Council Reference: DA04/0064.11 LN11043  
Your Reference: DA 492-11-2003 MOD 6

**Development Application DA 492-11-2003 MOD 6 (Council reference DA04/0064.11) - amendment to Development Consent DA04/0064 for a mixed commercial/retail tourist accommodation (DA 492-11-2003 MOD 6) at Lot 4 Sec 4 DP 172565; Land has no related Property or Address; Lot 23 DP 1064172; No. 32 Marine Parade KINGSCLIFF**

Figure 2: Proposed But Already Constructed Elevation

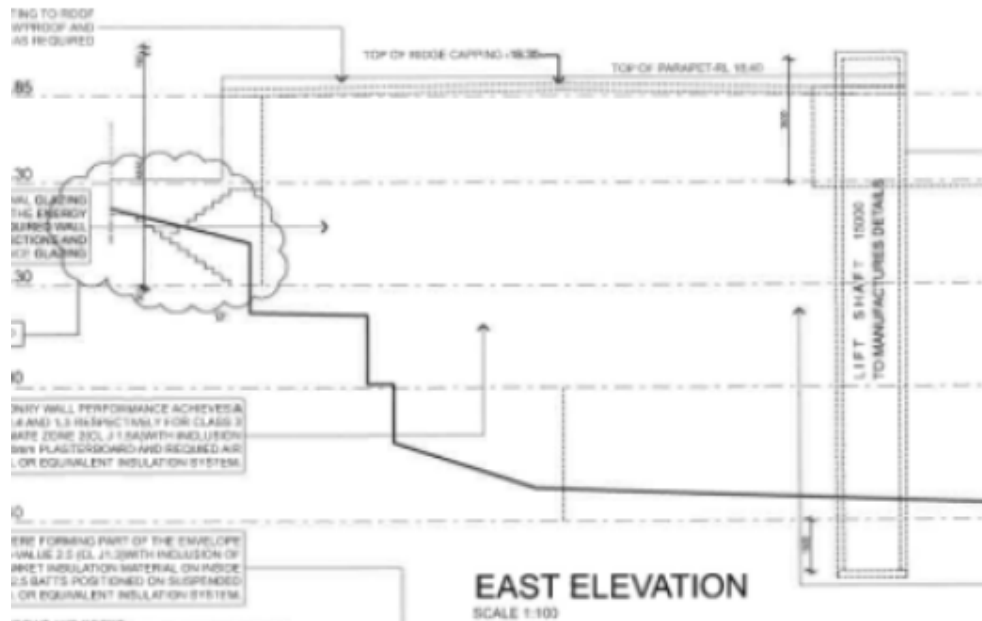
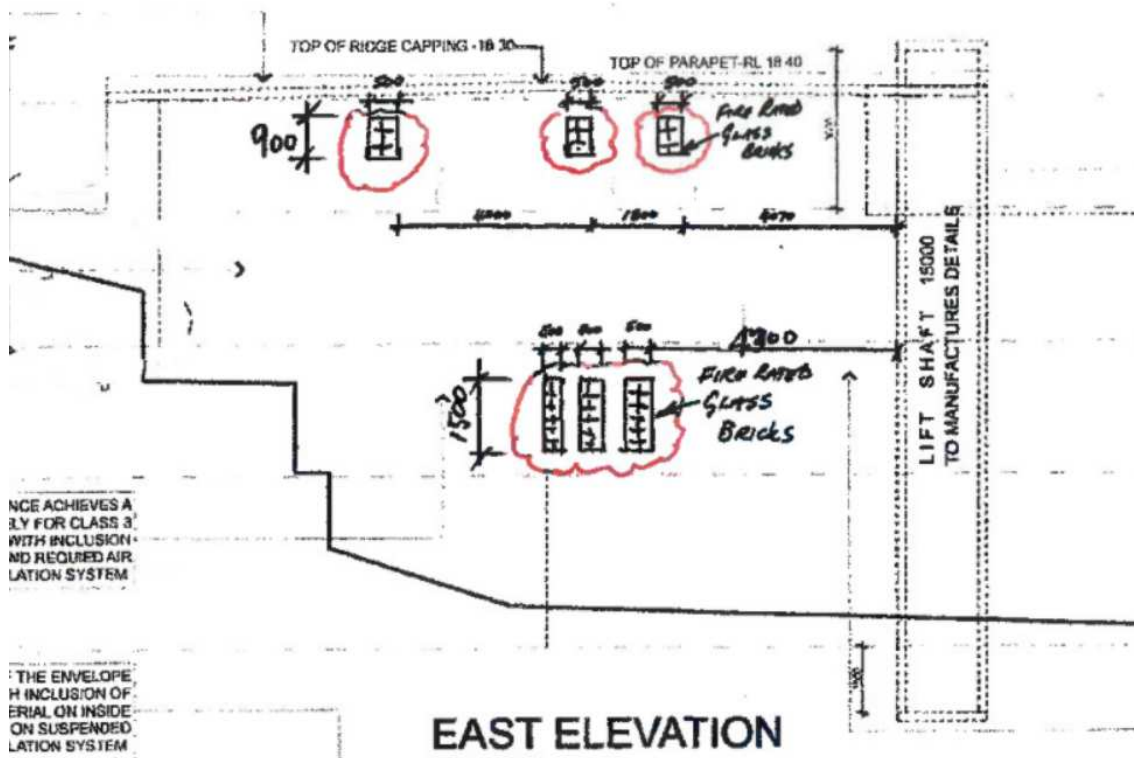
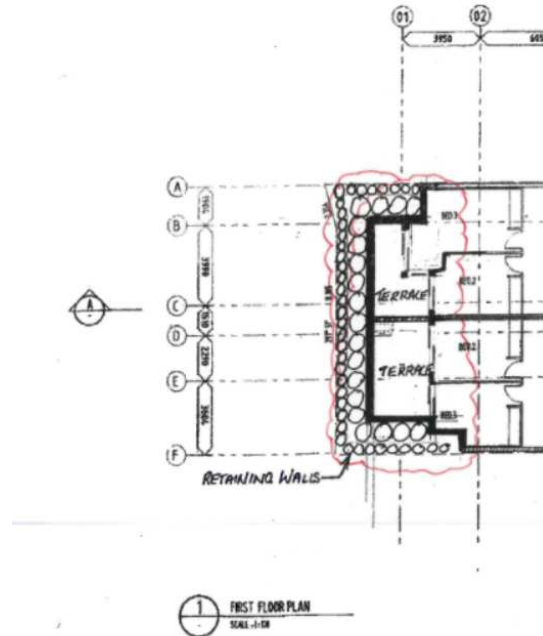
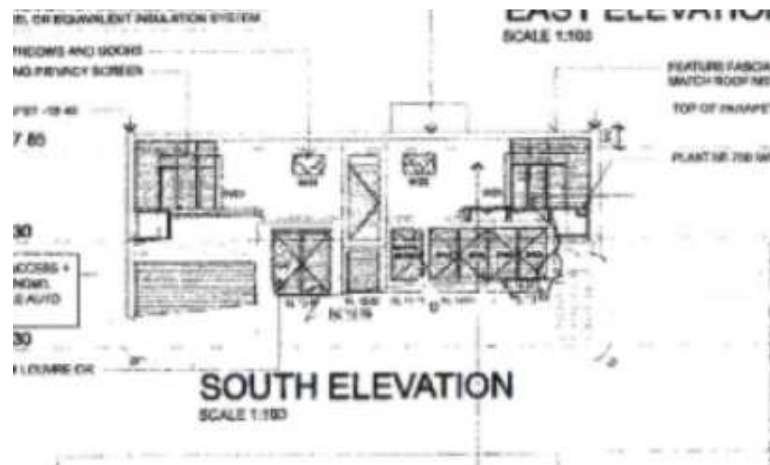
- Council notes that the proposed Inclusion of fire rated opaque glass bricks to the eastern external wall to the residential units to the first floor Unit 102 (media room) and third floor unit 301 (bed 1 & ensuite) will not affect the height; or have other detrimental impacts as highlighted in the original assessment or subsequent modification applications;

- The location of the opaque glass bricks is approximately 16 m along the eastern boundary. This puts the location of the proposed glass bricks approximately in between the carpark and the building adjacent. It is not considered that there will not be any effects on privacy.

- Council's Building Unit discussed the proposal with the applicant Nick Folkers from Evolve Planning Services. It is considered the fire rated glass blocks have already been installed in the south – eastern elevation on the first and second floors. Council's Building Unit raises no objection to the Section 4.55 application subject to a new condition being imposed requiring the lodgement of a building certificate for the works already undertaken without consent

- *Prior to the issue of any occupation certificate a Building Information Certificate in respect of the installation of fire rated glass blocks installed in the south – eastern elevation is to be obtained from Tweed Shire Council.*
